Sanimarin Toilet Controller Update

Bulletin Type:	TSB	Publication Date:	January 20, 2021
Bulletin #(s):	20-038	Make(s):	Entegra/Jayco
Job Code(s):	9803560	Model(s):	Embark, Reatta, Reatta XL, Aspire, Anthem, Cornerstone
Flat Rate(s):	.25 Inspection -per toilet .75 Install new control touchpad-per toilet	Model Year(s):	2021

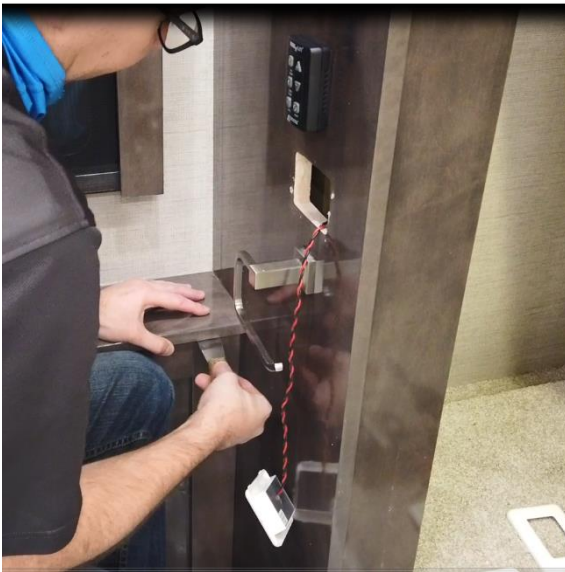
Verify brand of toilet installed in unit. If Sanimarin toilet is installed, remove touchpad to verify version of software (See step 1 of instructions). There is a label on the back of panel identifying revision. **Correct panel should show AC120147C or be labeled as "software update sample".**

NOTE: Some units may have multiple toilets, verify each toilet installed before ordering parts.
